From: [Andrew Breyer](#)
To: [Benabente, Julie](#)
Cc: [Paul Dunne](#); [O'Connor, Kevin](#); asimt@google.com; [Struyk, Zachary](#); [Cindy Muller](#); [Nathanael Miksis](#); [Barry Flynn](#); [Doug Boccignone](#)
Subject: Re: Follow-up Prior to 12/16 meeting
Date: Monday, December 9, 2019 2:25:37 PM
Attachments: [First set of Question to Google LLC 11012019 \(3\).pdf](#)

Questions for Google LLC:

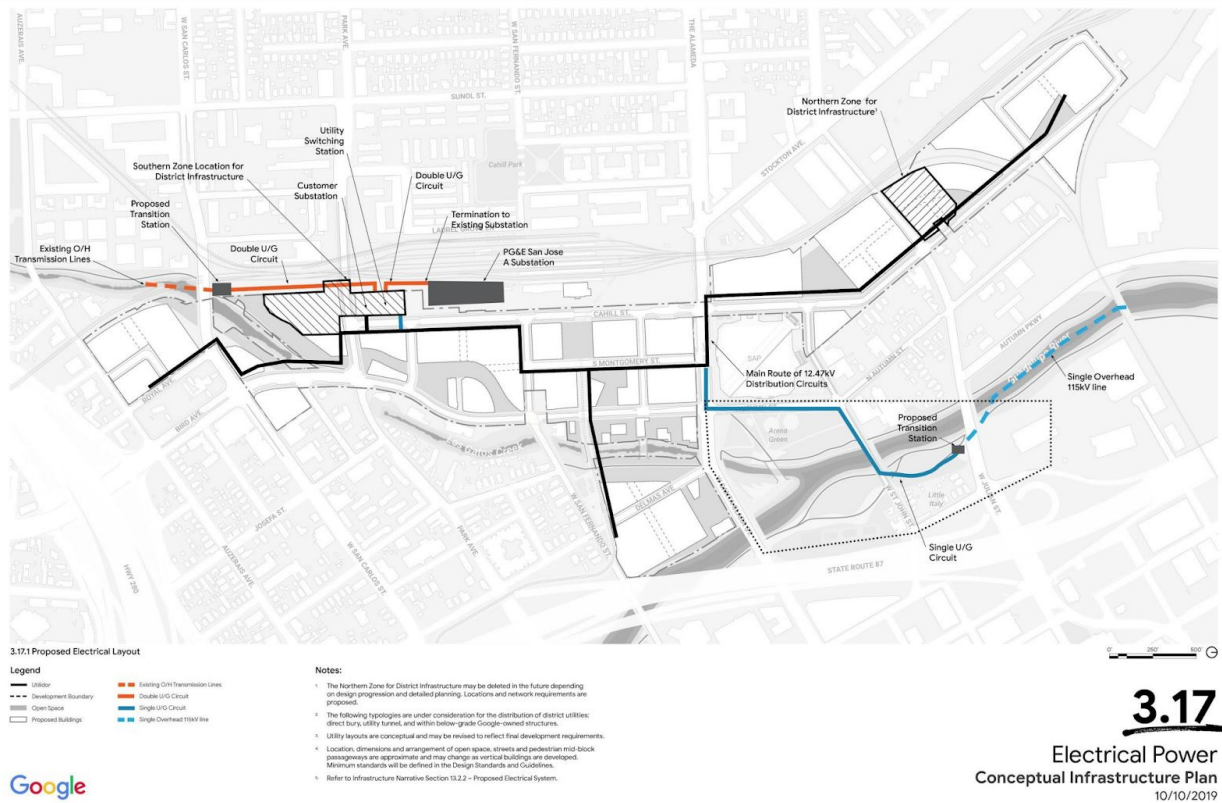
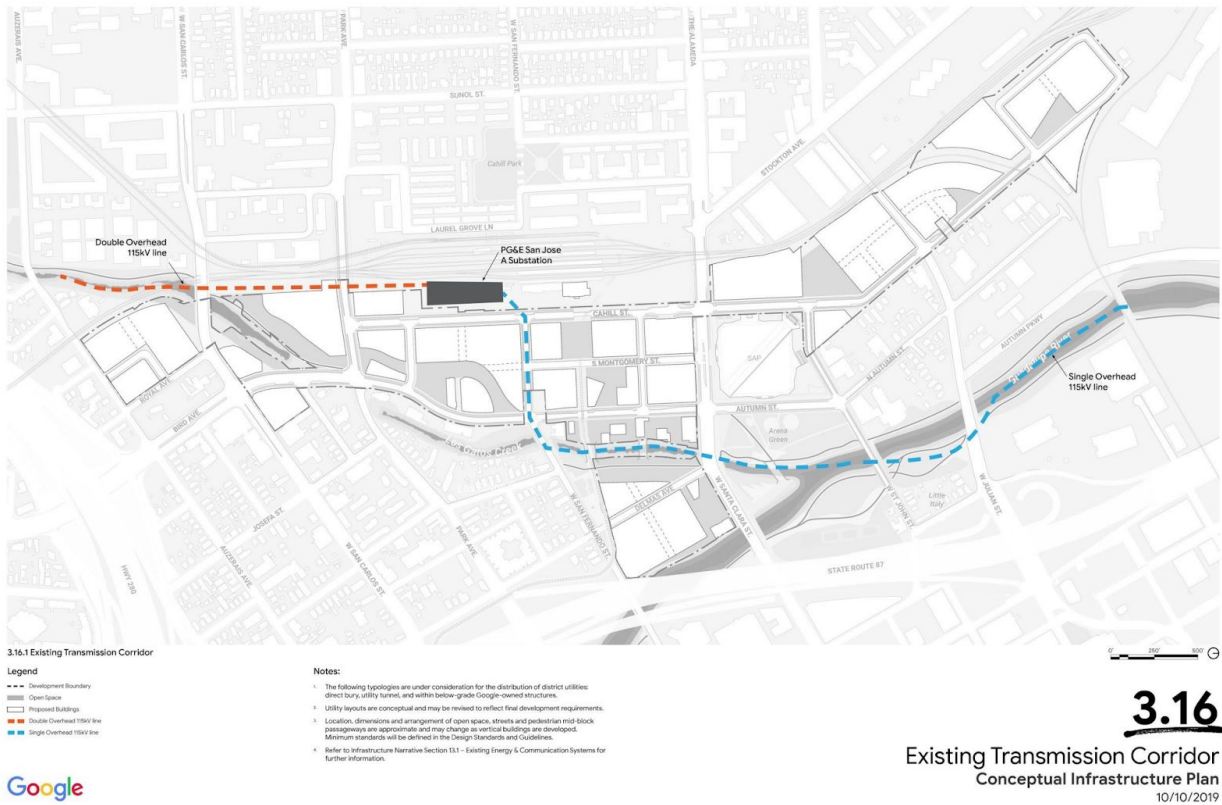
2. What was the criteria for sizing the onsite resources (generation and storage) as part of the currently envisioned advanced Microgrids? What is the capacity of the biogas generation? Was the capability to serve critical loads when the microgrid/s is/are separated from the main PG&E/CAISO grid considered?

Please elaborate.

- a. The initial sizes of the generation and storage has been based on space allocation assumptions for the project in conjunction with the project architect and an economic assessment that has been carried out against PG&E's E20-T tariff. These sizes were presented at our last meeting as well as via courier and are included below. Biogas generation has not yet been sized, but is not expected to be of a significant quantity to materially affect the below results.

- b. The vertical program and massing of the buildings has yet to be completed. As such, loads are not yet identified. We would expect within the boundary of the microgrid that as design is undertaken priority loads are identified. It is not expected that all of the Google loads are priority loads and that the development has to operate as normal in island mode with no load shedding. The microgrid can then be designed to serve these priority loads in the event of an outage. This will be via a microgrid control system and not via traditional hardwired systems such as automatic transfer switches. The battery storage sizing we have done to date has been an economic, not resilience

assessment. Should we identify key loads to be served that exceed the capacity of the generation we have identified above, we would consider alternatives such as increasing the hourly storage of the batteries.
